IC Corporation

SAFETY RECALL 05524

February 2006

VIN # (or List of VINs repaired)
Recall Campaign #05524
SUBJECT (Bus Control Arm Bracket)
Facilities Repair Labor Rate
Labor Operation Number
Your Tax ID Number

Figure 2. Old Bracket and Assembly

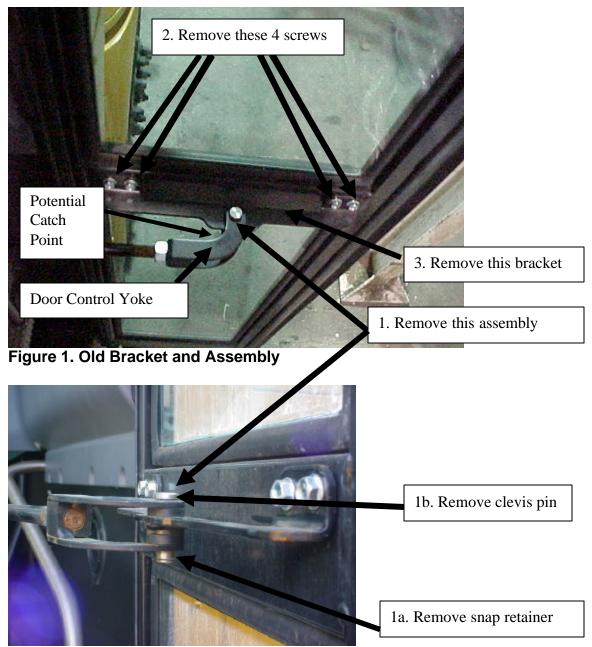
The door control bracket for the manual door control arm does not meet the guidelines in the NHTSA handbook for door entrance and handrail design.

There is a bracket mounted on the door that the door control yoke is attached to (See Figure 1, Potential Catch Point.) Certain small objects, including, but not limited to, coat tie strings with draw string clips or other objects attached thereto, could get caught in this catch point. Should this happen, and the driver does not properly observe the person exiting the bus, the person may exit the bus with the string caught between the bracket and the yoke. The door may be closed and the bus moved, causing possible injury or death to the passenger exiting the bus.

Remove Old Bracket: Refer to Figures 1 & 2.

- 1. Remove the door control yoke from the old bracket.
 - a. Remove the snap retainer at the bottom of the assembly.
 - b. Pull the clevis pin.
 - c. Be sure to note the order in which the parts are removed so they can be replaced or reinstalled in reverse order.
- 2. Remove the 4 screws that hold the bracket to the door. These screws are screwed into tapped holes. Be careful not to damage the threads of the tapped hole.
- 3. Once the 4 screws are removed, the old bracket can be removed.

Figure 3. New Bracket

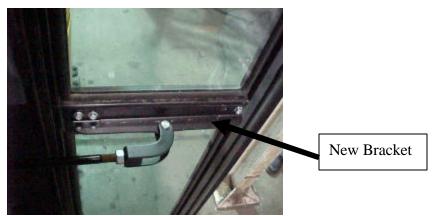
Install New Bracket: Refer to new bracket in Figure 3.

- 1. Place the new bracket in the same position against the door.
- 2. Replace the screws into the tapped holes on the door.
- 3. Torque screws to 15-20 LbF-Ft (20.4-27.1 Nm). Be very careful not to strip the threads in the door!
- 4. Re-attach the door control yoke to the new bracket by reinserting the clevis pin and snap ring. Ensure that spacers are positioned correctly.
